Development Services

APPEAL SUMMARY

Appeal ID: 19037	Project Address: 1125 NW Couch St
Hearing Date: 2/20/19	Appellant Name: Tom Jaleski
Case No.: B-010	Appellant Phone: 503-488-5651
Appeal Type: Building	Plans Examiner/Inspector: Brian McCall
Project Type: commercial	Stories: 10 Occupancy: B, M Construction Type: I-A
Building/Business Name: Brewery Block 4	Fire Sprinklers: Yes - Throughout per NFPA-13
Appeal Involves: Alteration of an existing structure	LUR or Permit Application No.: 18-272789-CO
Plan Submitted Option: pdf [File 1]	Proposed use: Office

2 PROPOSED 4TH FLOOR ROOF TERRACE OCCUPANCY PLAN

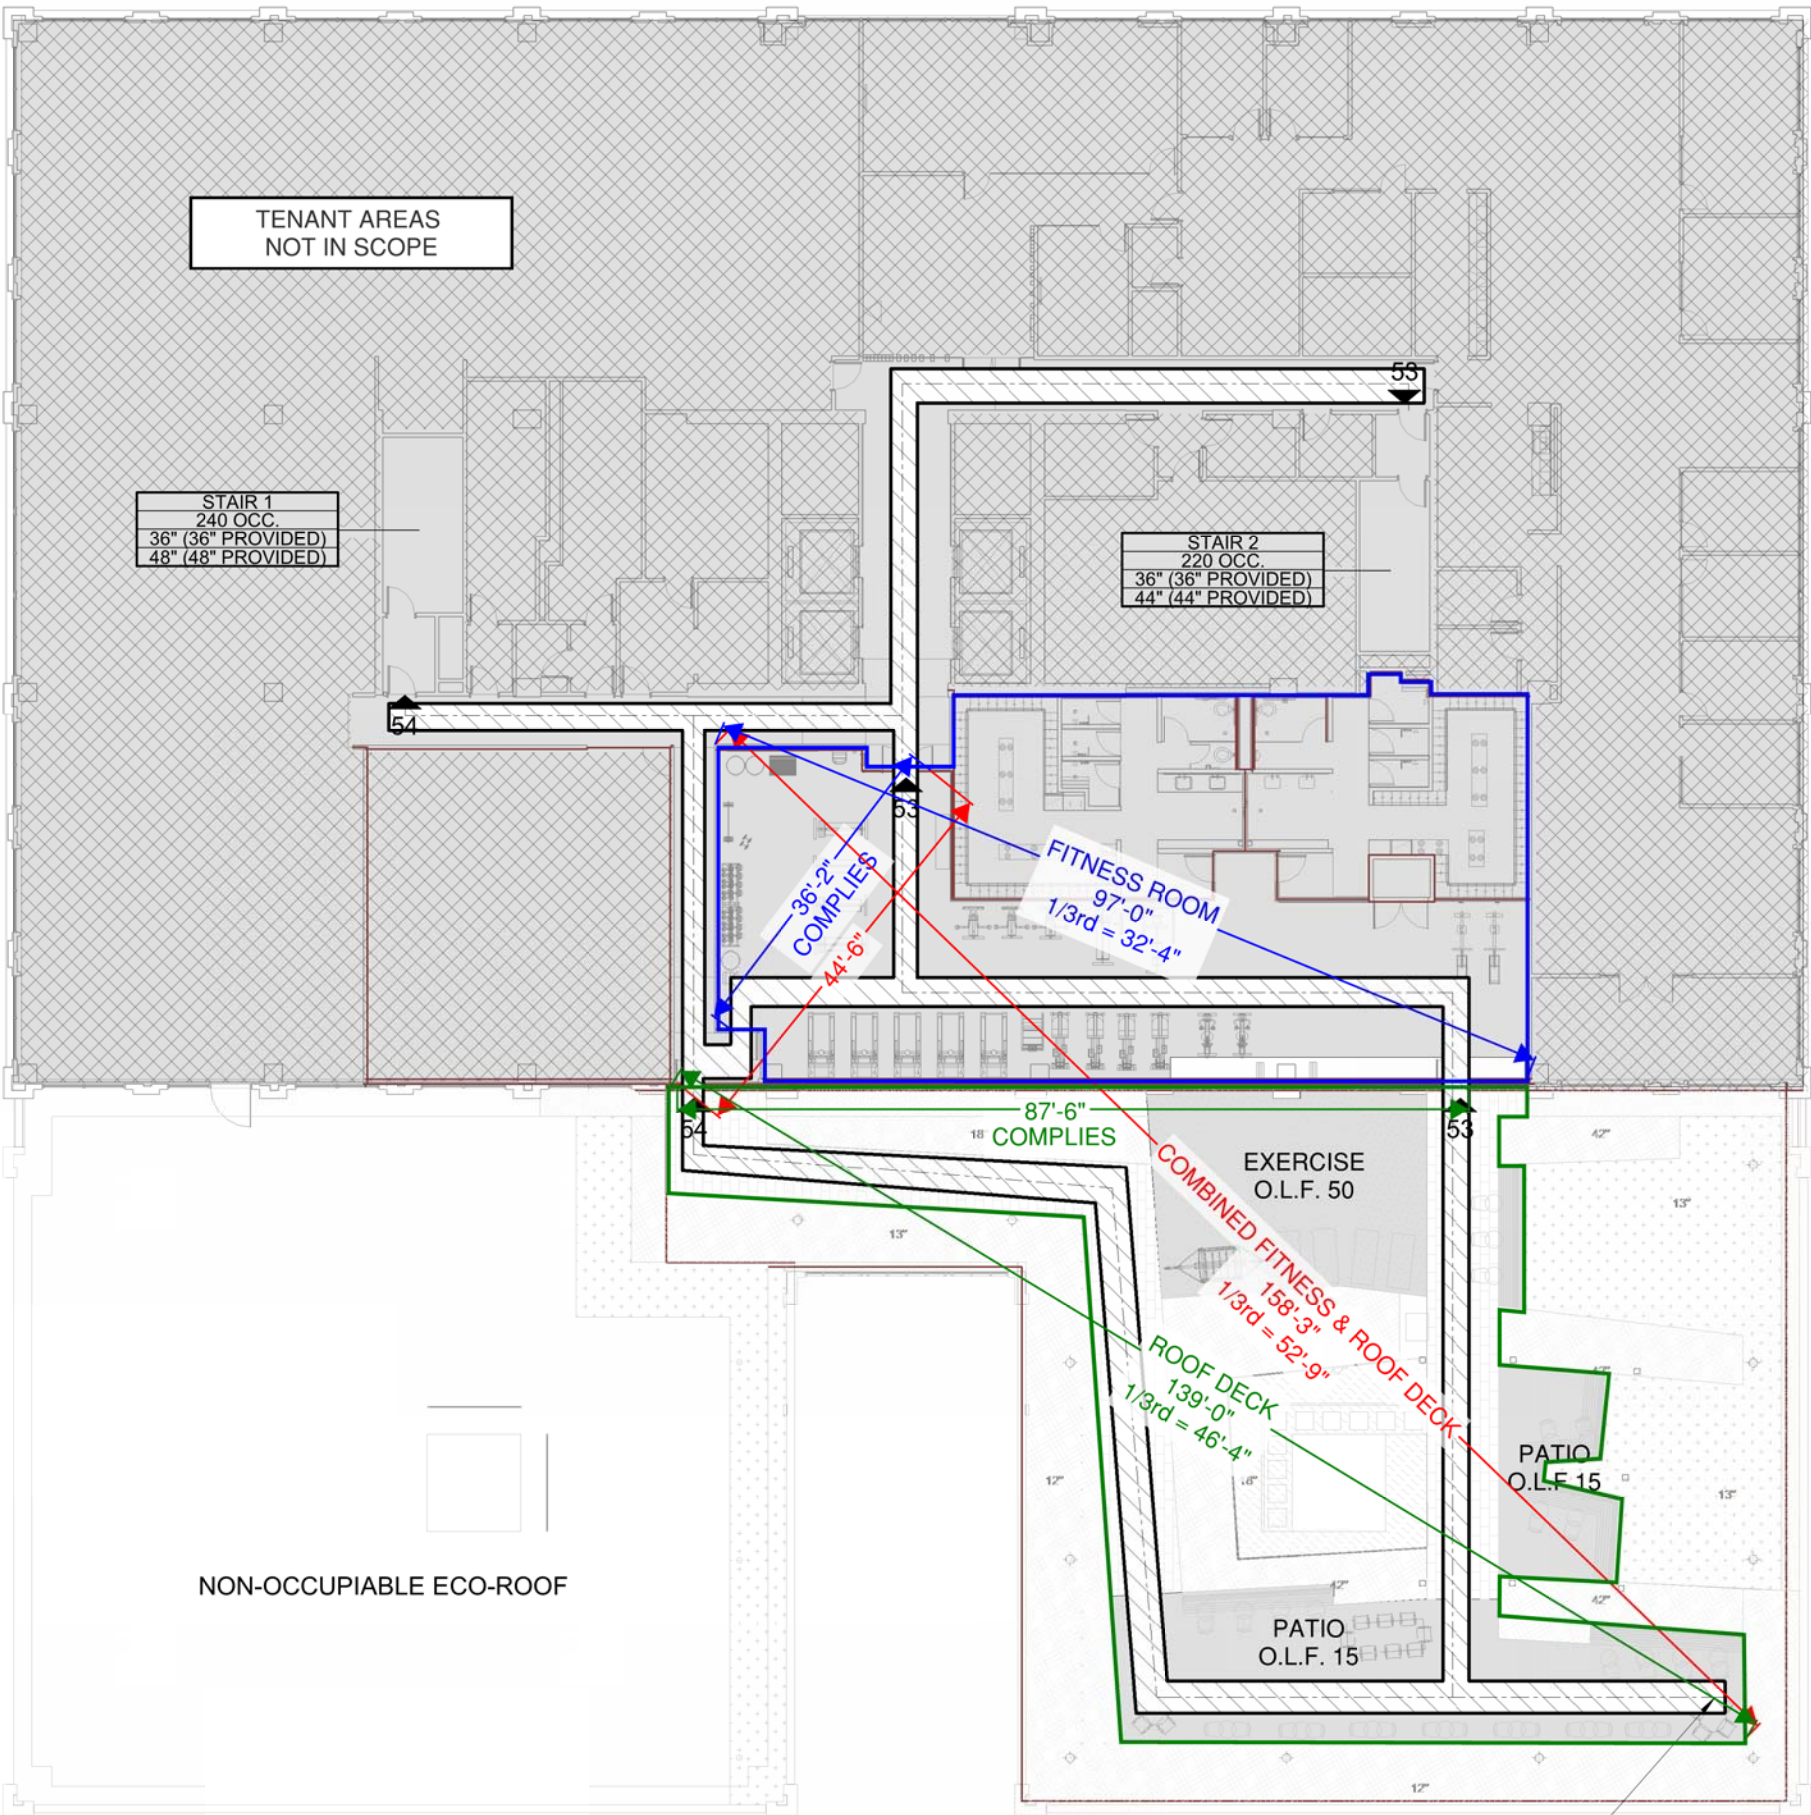
- Smoke detection throughout the fourth floor that initiates voice annunciation at exterior and interior amenity areas.
- Exits from the combined fitness room and roof deck separated by approximately 28% of the maximum overall diagonal
- Exits from the combined fitness room and roof deck separated by a corridor wall corner

Reason for alternative One exit route from the roof deck enters directly into a corridor, and the other travels through the fitness room with fixed equipment on a route at least 44" wide. Exit separation meeting prescriptive requirements is provided for the overall floor, for the roof deck individually, and for the fitness room individually, but not for the combined area of the fitness room and roof deck together. The required separation is 52'-9", and the separation provided is 44'-6", which is approximately 28% of the maximum overall diagonal distance. Due to tenant spaces on Level 4, it is technically infeasible to

Each exit route from the combined fitness room and roof deck area enters into different parts of the same corridor. They are located around a corner from each other, and thus separated by a corridor wall, which would not normally be required for exits from a room. The egress paths do not need to intersect, since exit stairways are provided in opposite directions from each exit access doorway.

With smoke detection providing early warning to occupants, and an exit access doorway separation of 44'-6" divided by a corridor wall corner, equivalent or greater protection will be provided.

2. Reduction in minimum exit separation distance from 33 percent to 28 percent: Denied. Proposal does not provide equivalent Life Safety protection.
